ENCLOSURE 1

Examination Report No.: 50-206/OL-92-01
Facility: San Onofre Nuclear Generating Station Units 1
Docket Nos.: 50-206

Examinations on April 27 - May 9, 1992 (Report No. 50-206-OL-92-01)

FIGURE 5: ROD CONTROL PROGRAM

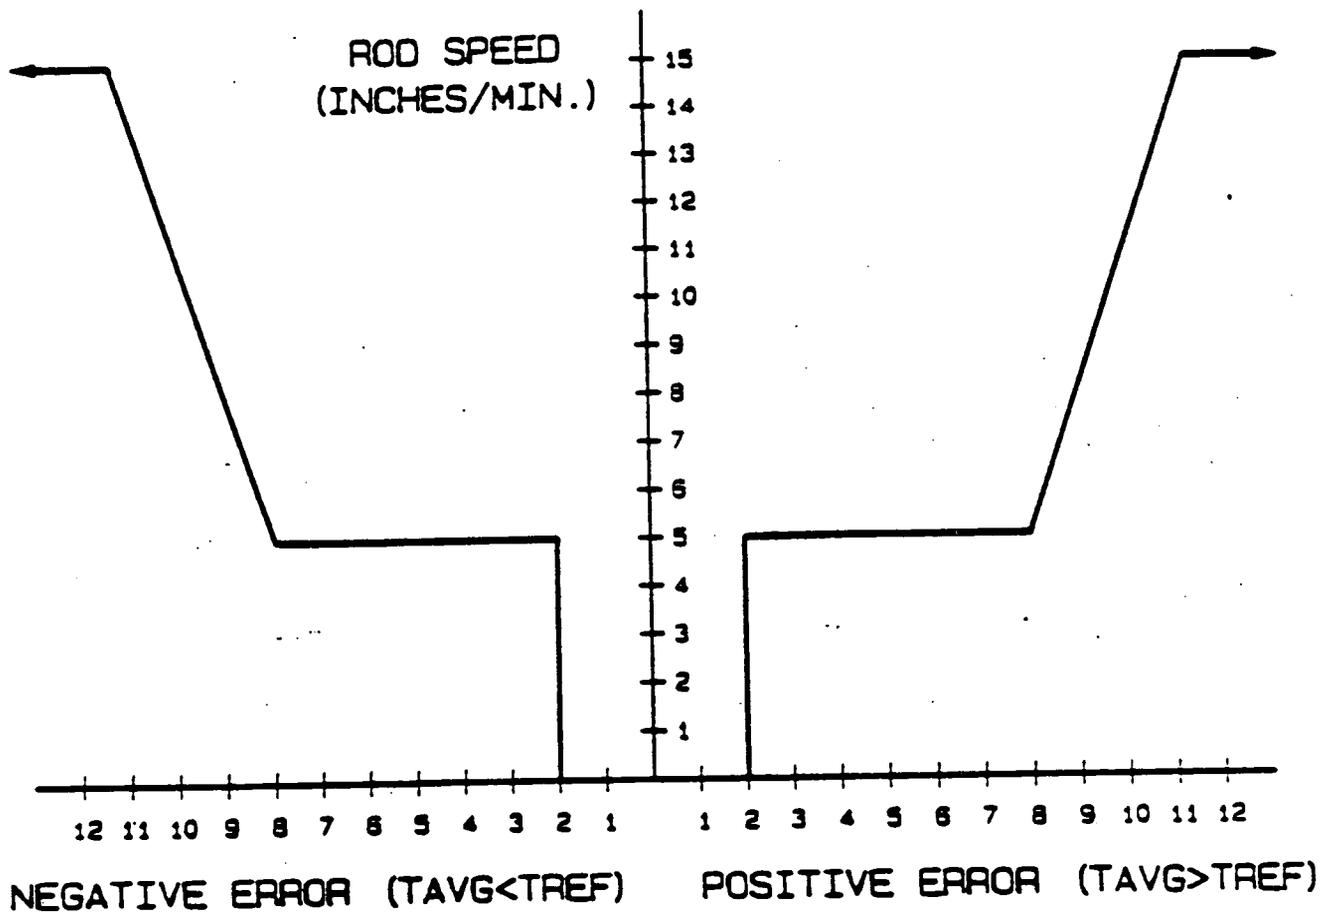
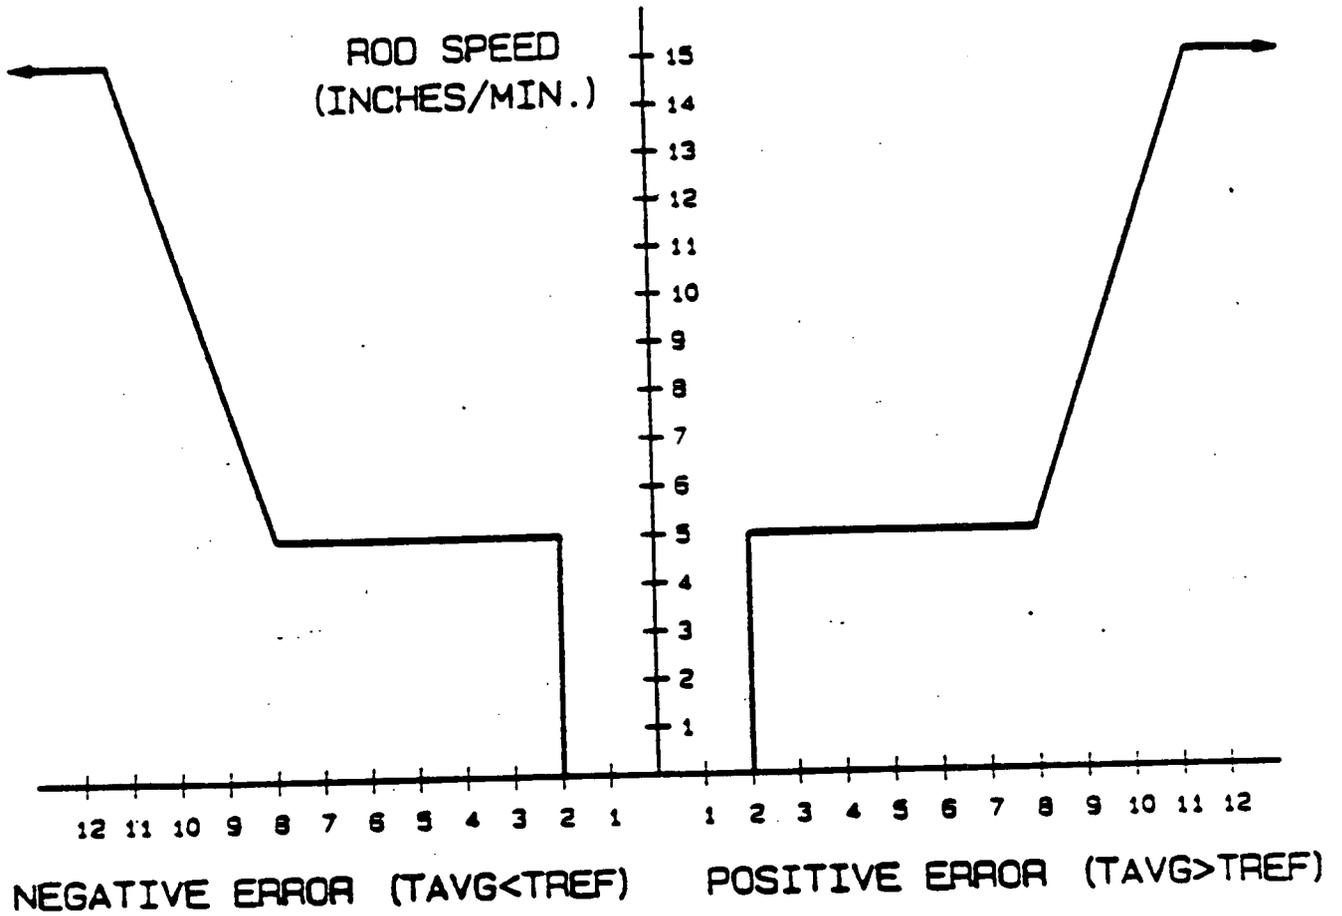
this question, it discusses the fact that the rod speed is variable between 5" to 15"/min and provides a handout/TP entitled Figure 1-7. This figure is similar to the graph referenced in the system description but is drawn correctly.

SD-S01-400, Rod Control System, Pg. 6, properly discussed the correct Tavg program, this is the choice that the NRC chose as correct. The NRC examiner did not check the accuracy of SD-S01-400, Figure 5, but included it on the examination and this is what led to their being two correct answers.

NRC REFERENCE PROBLEMS: L.P. 1XI203, Rod Control System, Obj 1.3.2 ; Pg 26, does not address this question clearly. Page 12, in lesson plan 1XI203 is the proper location to address this question, it discusses the fact that the rod speed is variable between 5" to 15"/min and provides a handout/TP entitled Figure 1-7. This figure is similar to

SD-S01-400, Rod Control System, Pg. 6, properly discussed the correct Tavq program, this is the choice that the NRC chose as correct. The NRC examiner did not check the accuracy of SD-S01-400, Figure 5, but included it on the examination and this is what led to their being two correct answers.
